UNITED STATES PATENT AND TRADEMARK OFFICE

APPLICATION NO.	FILING DATE	FIRST NAMED INVENTOR	ATTORNEY DOCKET NO.	CONFIRMATION NO.
09/978,577	10/18/2001	Joseph B. Vergona	53394.000491	5207

# Office Action Summary

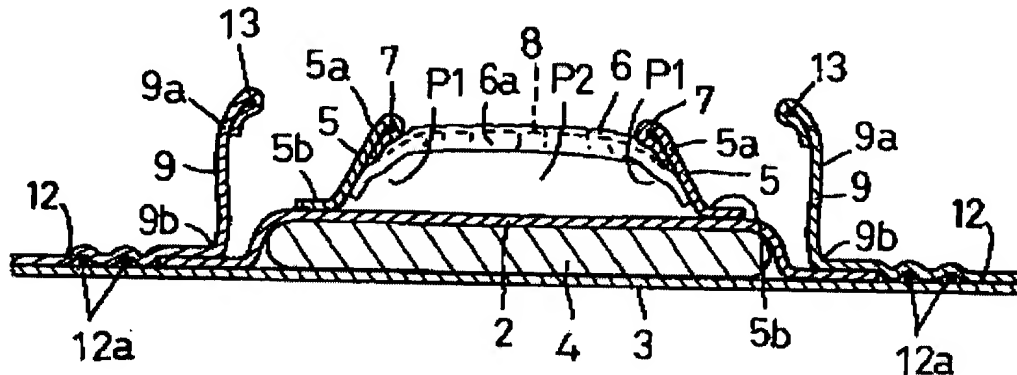
Regarding claim 1, Mishima *et al.* teach an absorbent article (1) comprising:

an absorbent core (4) disposed between at least a portion of said top sheet (2) and at least a portion of said back sheet (3), wherein a first pair of vertical cuffs (5) are mounted on the top sheet (2) opposite one another along respective side edges (5b) of said absorbent core (4), said top sheet (2) and said absorbent core forming a core assembly (2, 4), wherein said first pair of vertical cuffs (5) extend upward from respective side edges (5b) of said core assembly (2, 4) to define a first region there-between for containing body exudates; and

a second pair of vertical cuffs (9) mounted on said back sheet (3) on opposite sides of said core assembly (2, 4) and laterally outboard of said first pair of vertical cuffs (5), creating a second region between said core assembly (2, 4) and said second pair of vertical cuffs (9) for containing body exudates (*see* Fig. 5, below).

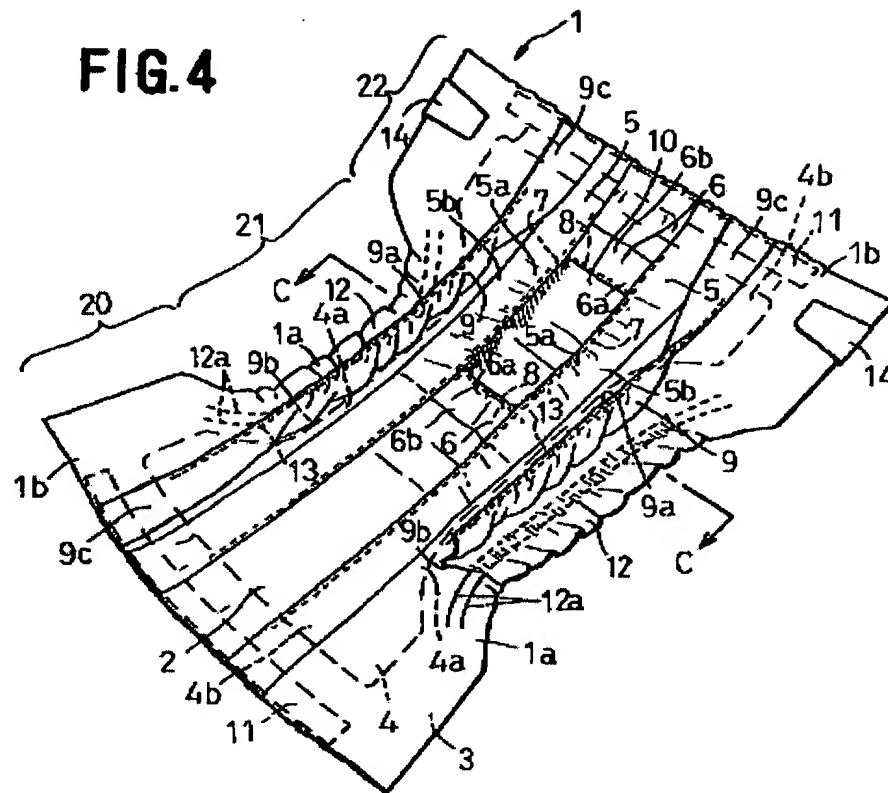
Regarding claim 9, Mishima *et al.* teach a first pair of vertical cuffs (5) extending along the entire length of the core assembly (2, 4) (*see* Fig. 4, below).

Regarding claim 11, Mishima *et al.* teach a second pair of vertical cuffs (9) extending along the entire length of the back sheet (3)(*see* Fig. 1, above).

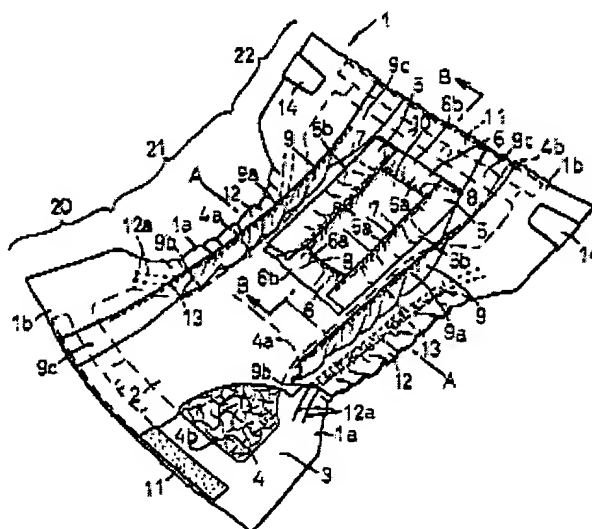
Regarding claim 10, Mishima *et al.* teach a first pair of vertical cuffs (5) extending only partially along the length of the core assembly (2, 4)(see Fig. 1, below).

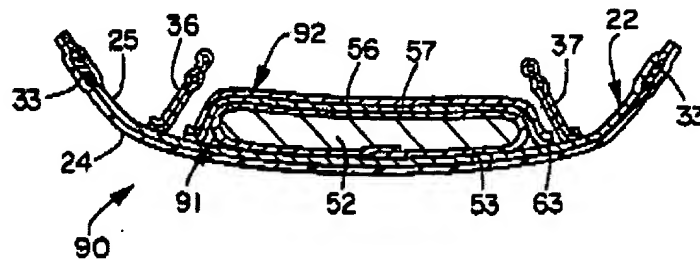
Roessler *et al.* teach a transfer layer (57)(see Fig. 10, below).

At the time of the invention, it would have been obvious to one of ordinary skill in the art to combine the transfer layer of Roessler *et al.* with the diaper as taught by Mishima *et al.* in order to enhance diaper dryness (see Roessler *et al.* col. 11, lines 47-51).
